Model: Bellini		Date: 31-Jan-00	No.: MA294001
Modified Article: Parts Catalog		Prepared by: H. K.	
From: Technical Services Dept., GTS Division			
Reason for Modification:	☒ Parts catalog correction ☐ To facilitate assembly ☐ Part standardization	☐ Vendor change ☐ To improve reliability ☐ Other	☐ To meet standards ()

Model: Bellini		Date: 29-Feb-00	No.: MA294002
Modified Article: Rear Fusing Plate & Right Lower Fusing Stay		Prepared by: H. Kobayashi	
From: Technical Services Dept., GTS Division			
Reason for Modification:	☐ Parts catalog correction ☐ To facilitate assembly ☐ Part standardization	☐ Vendor change ☒ To improve reliability ☐ Other	☐ To meet standards ()

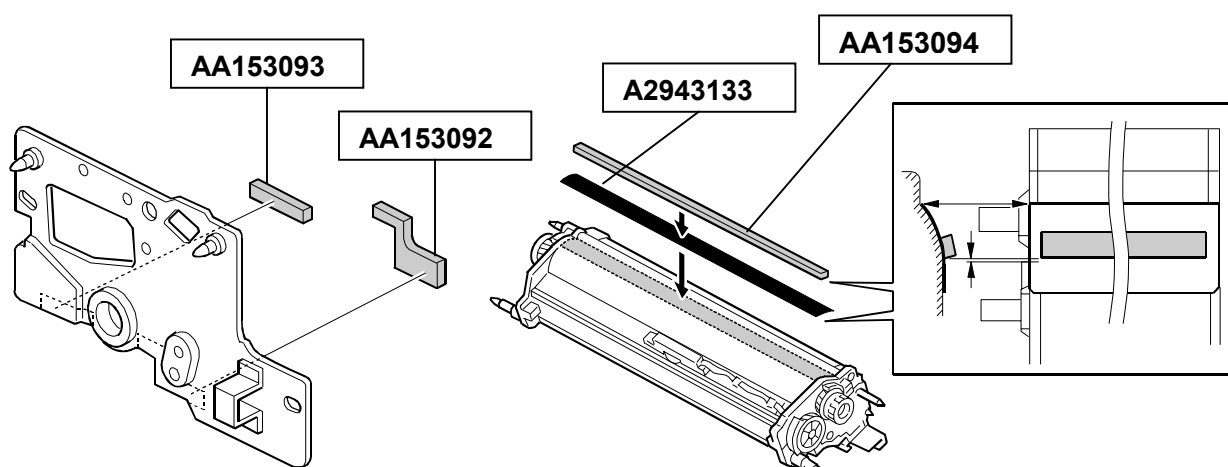
To minimize toner dusting, the following countermeasures have been applied to the development unit and drum stay.

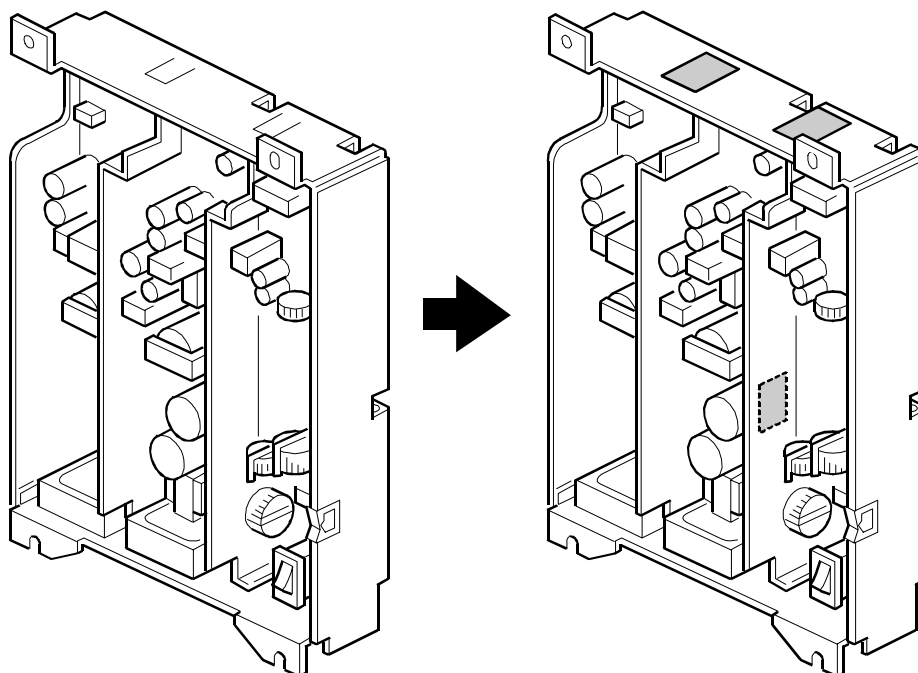
Fibers of the anti-static brush and particles worn off the drive belt surface cause sparks, which damage the PSU.

To ensure that this does not occur, three seals have been added as shown.

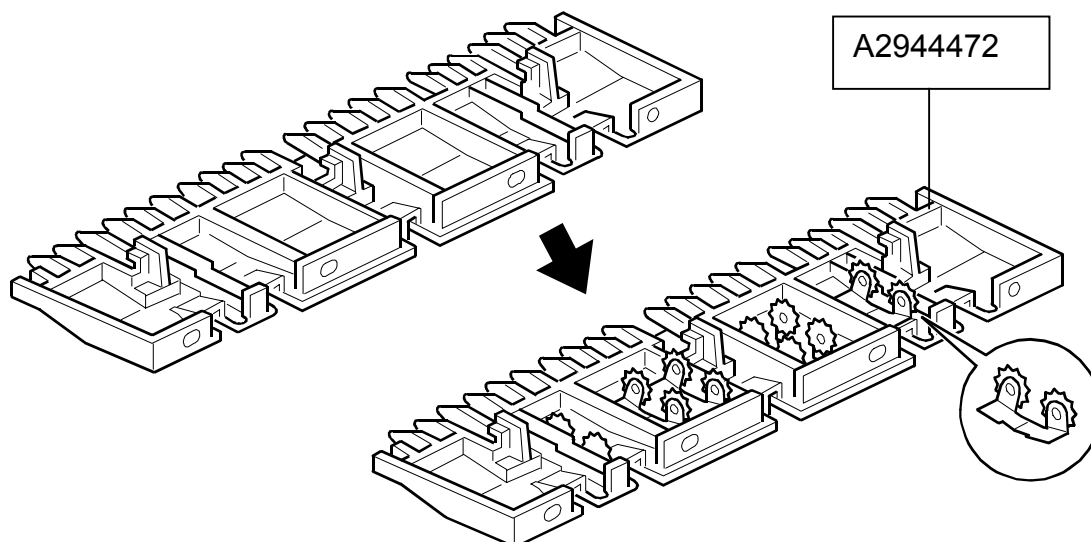
When the paper touches the upper fusing guide plate, toner on the paper may be transferred to the guide plate and the toner on the guide plate may be transferred to the next sheet of paper. This symptom is visible on the side face of a copy stack.

To prevent toner from being transferred to the guide plate, twelve spurs have been added to the upper fusing guide plate.

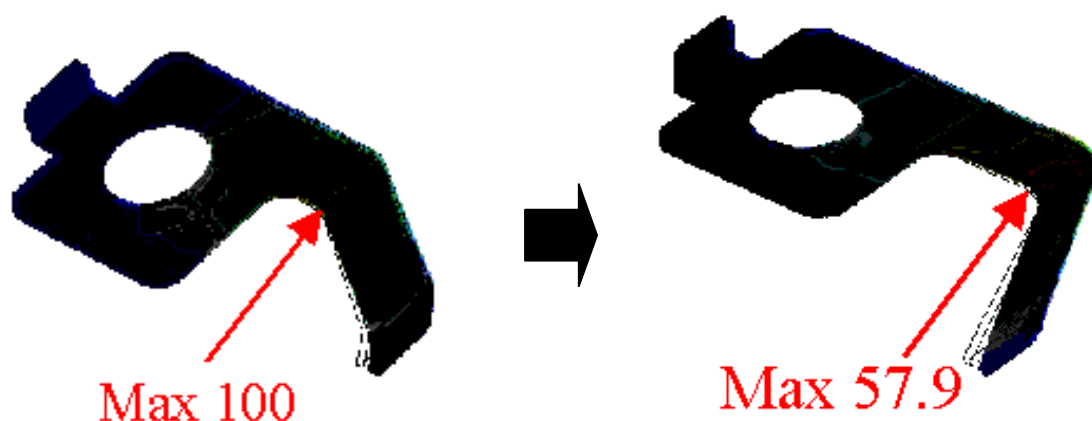
The spring plate contained in the stopper bracket can sometimes break due to the plate's load distribution. The plate's shape has been changed as shown below (rounding, lengthening, and angle change in the area shown) in order to more evenly distribute the load.

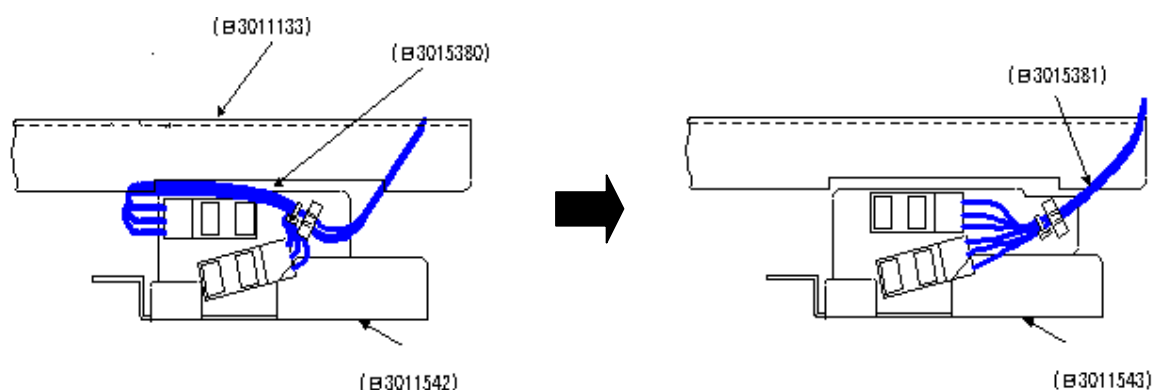
To prevent contact with the right stay (B3011133), the installation routing of the DF position sensor harness has been changed as shown below.

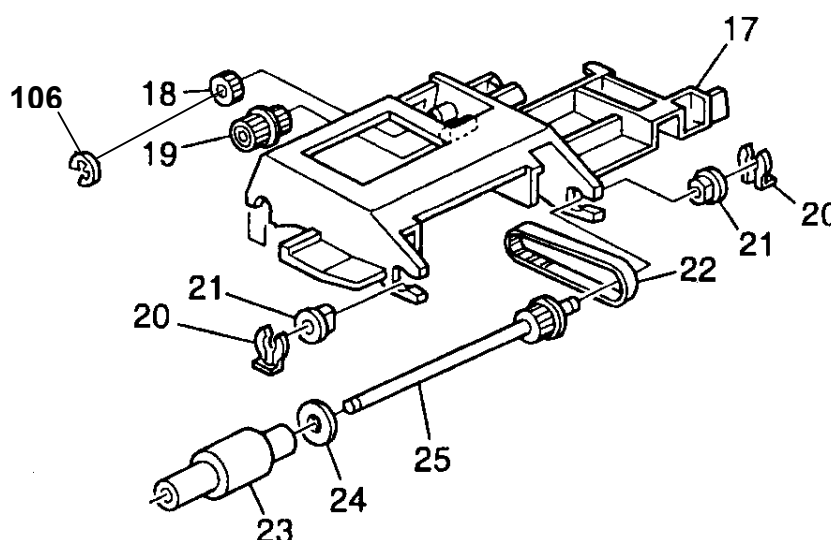
To improve reliability, the material of one of the drive gear shafts has been changed from resin to metal, and an e-ring has been added to the shaft.

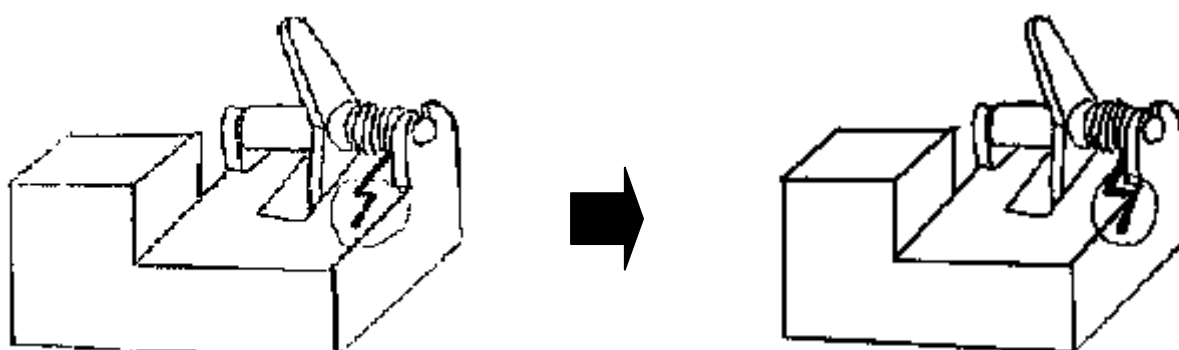
1. For the Bellini, Mojito, and SP5, the photointerruptor must be **replaced** with the new type.
2. Both parts can be used for all other machines. However, when using the old photointerruptor, be sure to **hook the spring arm on the side of the resin case as shown below**.

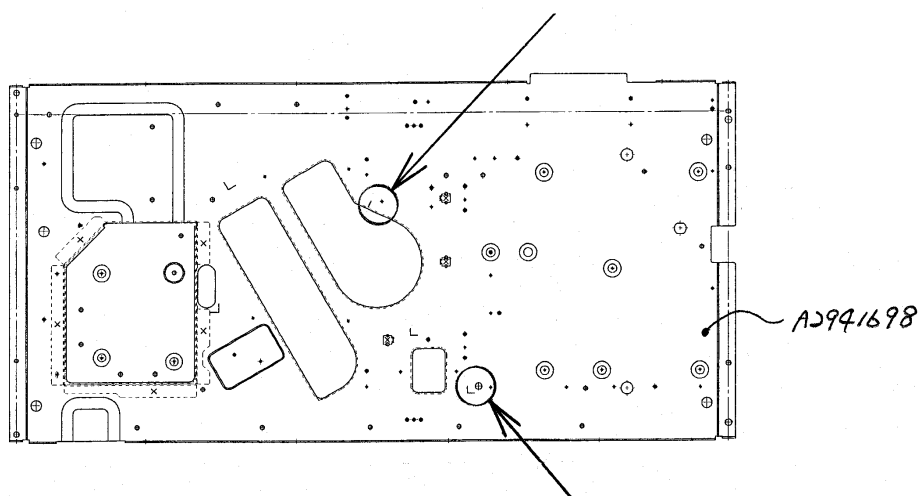
Note: When installing the Base Frame, attach the Seals to the areas shown by the arrow in the illustration below.

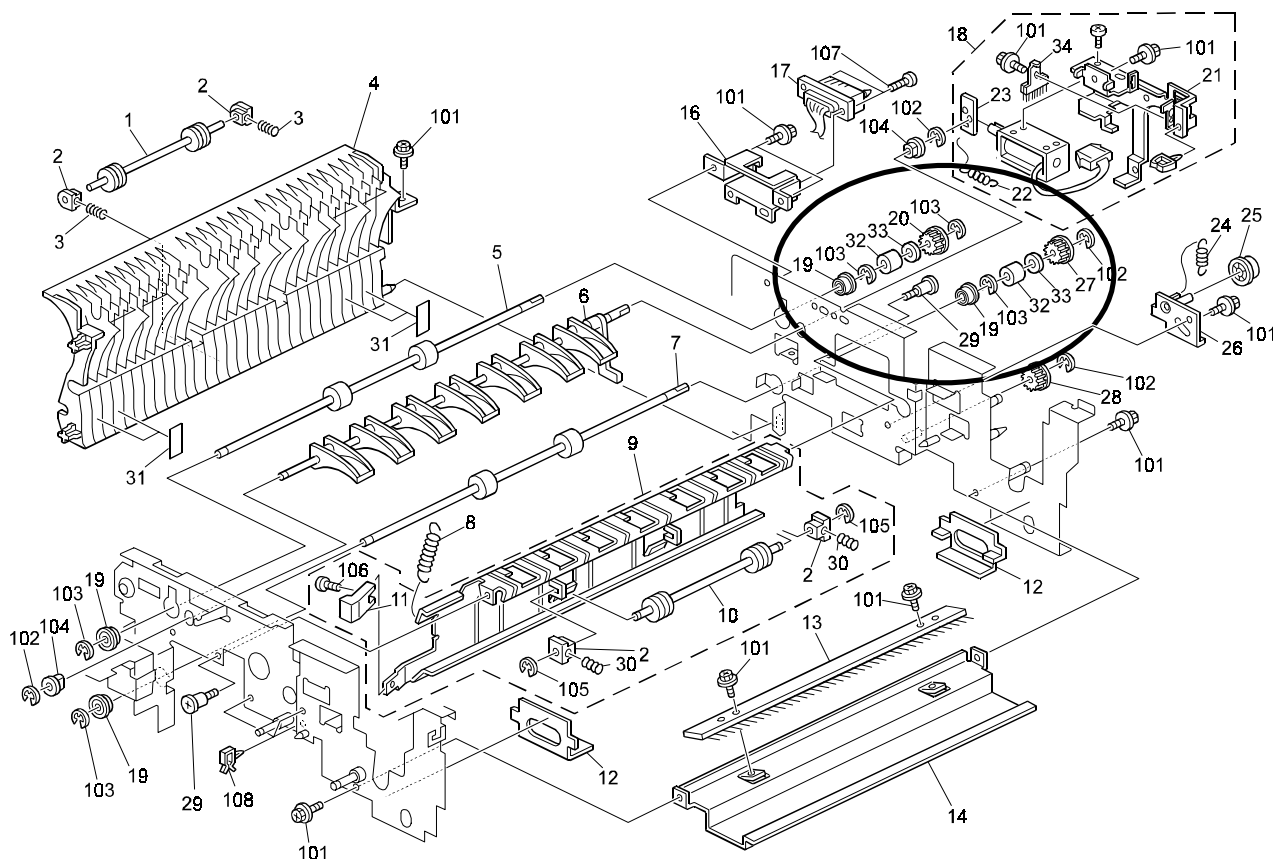
To prevent the timing belt from slipping off, a spacer and collar have been added as shown below.

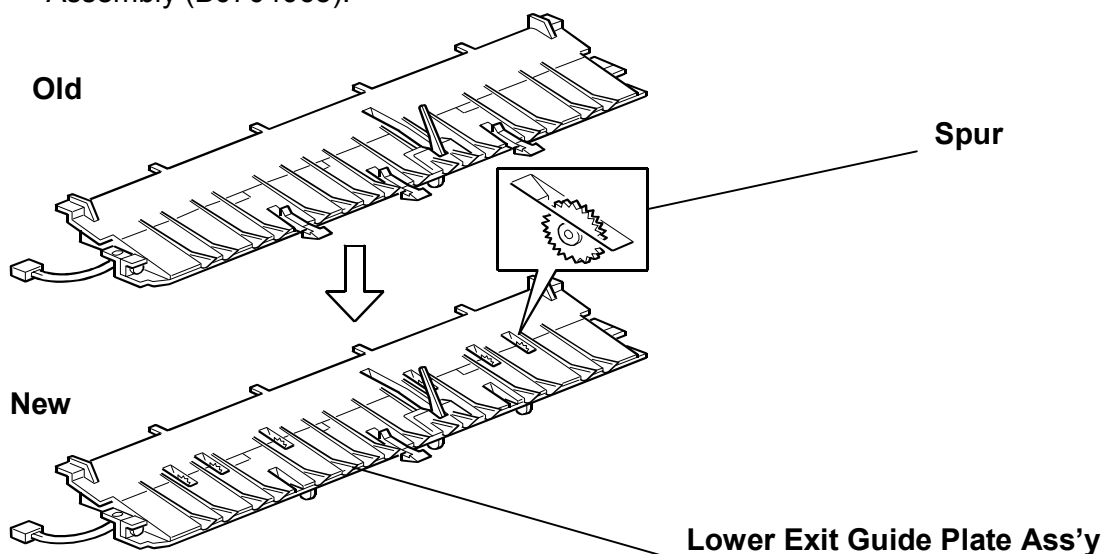
1. Please note that the interchangeability can differ from part to part, as shown above.
2. Since the old Lower Exit Guide Plate (A2944076) is no longer available as a Service Part, if this part requires replacing in the field, please install the new Lower Exit Guide Plate Assembly (B0704063).

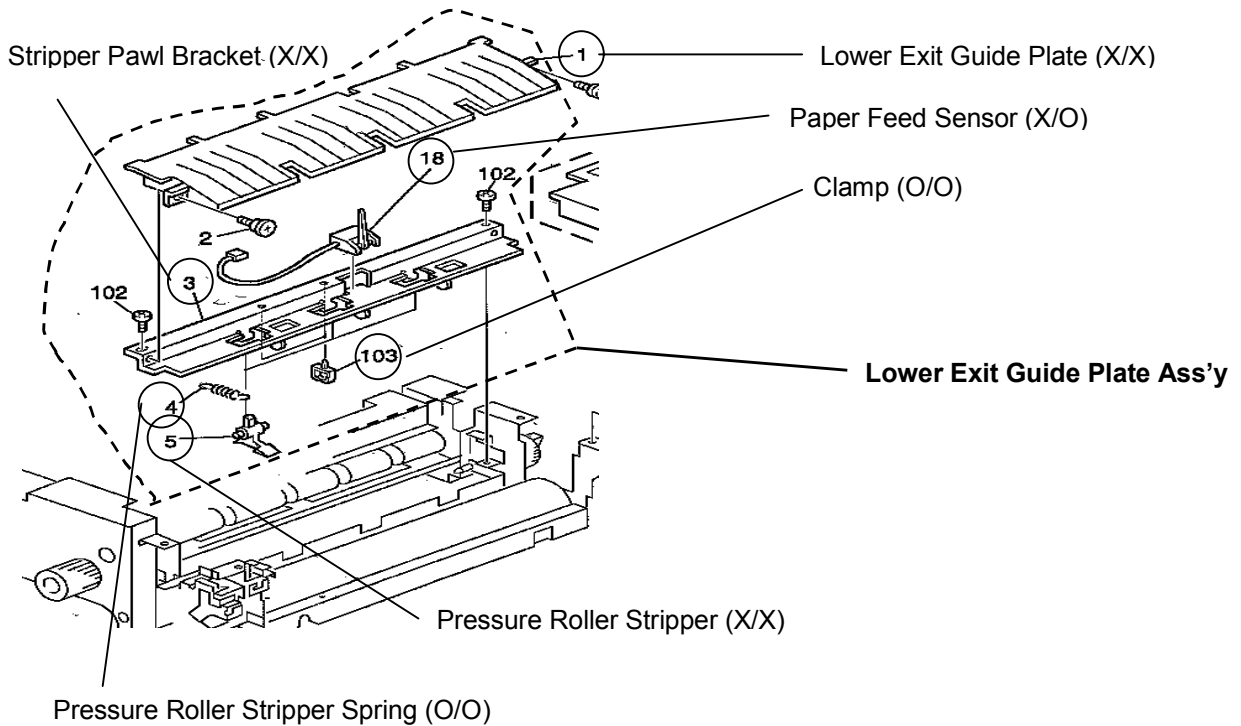
1. In accordance with the Plate modification, the Stripper Pawl Bracket (shape change), Pressure Roller Stripper (shape/qty change), and Paper Feed Sensor (type) have also been changed.
2. Due to parts standardization, the Spring for the Pressure Roller Stripper and Clamp have been changed.

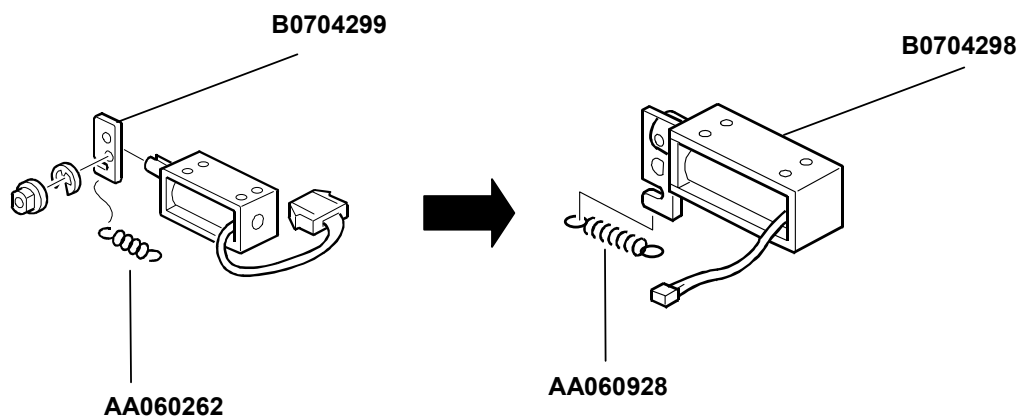
Note*2: To facilitate assembly in the field, B0704299 has been discontinued in place of B0704298 (see the illustration below).

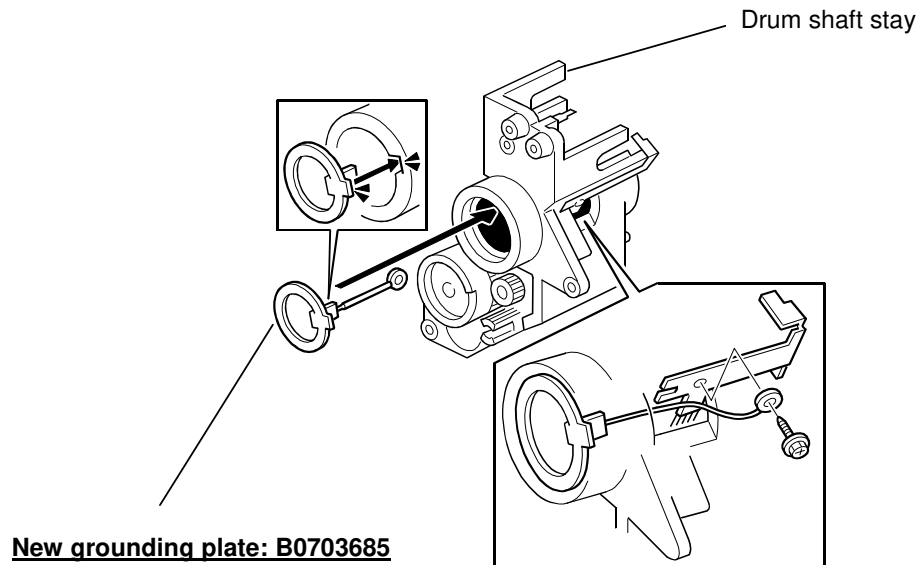
Note: The new grounding plate should be installed **together with** the drum shaft stay (A2943680).
